Purpose

MTU Onsite Energy is now offering a Low Coolant Level Switch that is compatible with both modern and existing system control logic. The following instruction describes replacing the existing switch with the new model on units in the field. Contact your MTU Onsite Energy Service Department at service-oed@mtu-online.com or +1 800 325 5450 if you have any questions or additional concerns related to this instruction.

Sensor Replacement Information

Figure 4

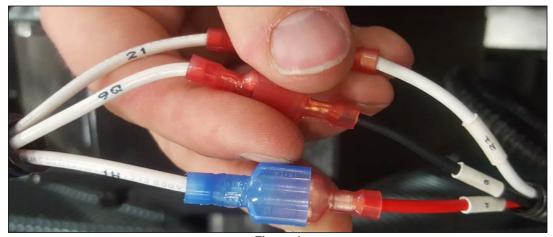
- 9. Wire the sensor to the generator.
 - o If using X00A69900004 or X00A69900002, simply plug the connector in until it clicks.
 - o If using X00A69900008, use the following instructions (See Figure 4):
 - Red (+) #1 wire attaches to white #1 wire on generator set.
 - White (Sig.) #21 wire attaches to white #21 wire on generator set.
 - Black () #9 wire attaches to white #9 wire on generator set.

Figure 5

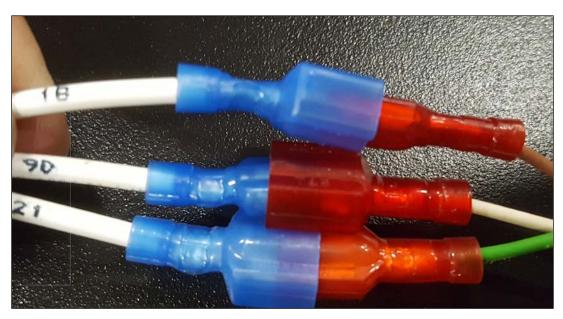
- o If using X00A69900003 or X00A69900005, use the following instructions (See Figure 5):
 - White (-) connects to wire #9
 - Green (Sig.) connects to wire #21
 - Brown (+) connects to wire #1
